From: Camille Leung
Sent: Thursday, April 21, 2022 4:34 PM
To: Melody Eldridge
Cc: Amy Ow
Subject: RE: Comments on O&M Agreements for Lots 9-11
Attachments: Recorded Lot 5-11 Tract Map.pdf

From: Camille Leung
Sent: Wednesday, December 1, 2021 7:44 PM
To: Jonathan Tang (jtang@BKF.com) <jtang@bkf.com>; Jack Chamberlain (jtuttlec@aol.com) <jtuttlec@aol.com>
Cc: robertpellegrine@yahoo.com; Melody Eldridge <meldridge@smcgov.org>; 'Larry Jacobson (laj@cohenandjacobson.com)' <laj@cohenandjacobson.com>; RNewman@ResolutionStrategiesInc.com
Subject: Comments on O&M Agreements for Lots 9-11
Importance: High

- BLD2016-00160 (2185 Cobblehill) – Lot 9, NOM2021-00007
- BLD2016-00158 (2184 Cobblehill) – Lot 10, NOM2021-00008
- BLD2016-00159 (88 Cowpens) – Lot 11, NOM2021-00009

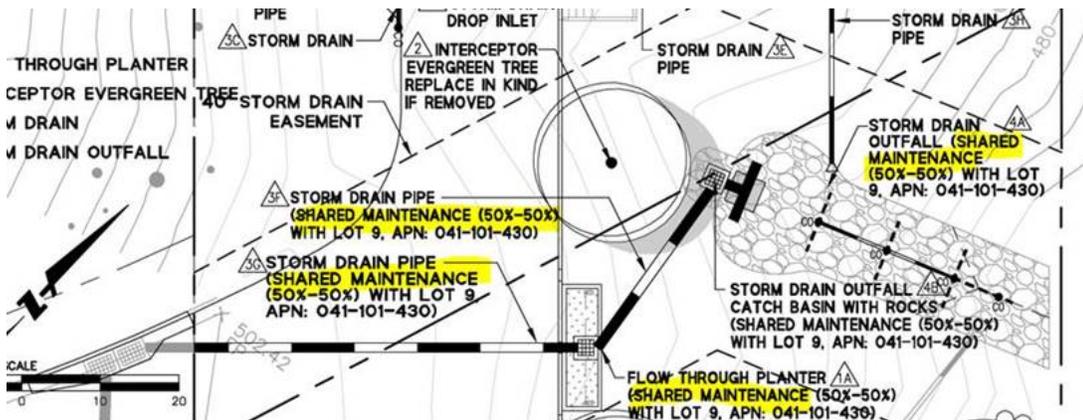
These O&Ms definitely comply with the shared maintenance of the bioretention planter/outfall (see screenshot below of the site map/responsibility).

However, the stormwater treatment O&Ms typically don't have anything to do with maintenance for a standard driveway (e.g., non-permeable). I'm not quite sure how we would incorporate that into this doc – because we wouldn't want to take inspection/reporting responsibility for it... Is there another doc out there for the driveway/access easement maintenance?

Thanks Melody! DPW required a Private ingress/egress access easement over the shared driveway which should cover maintenance (if not it will be a civil issue). See Page 5 of attached.
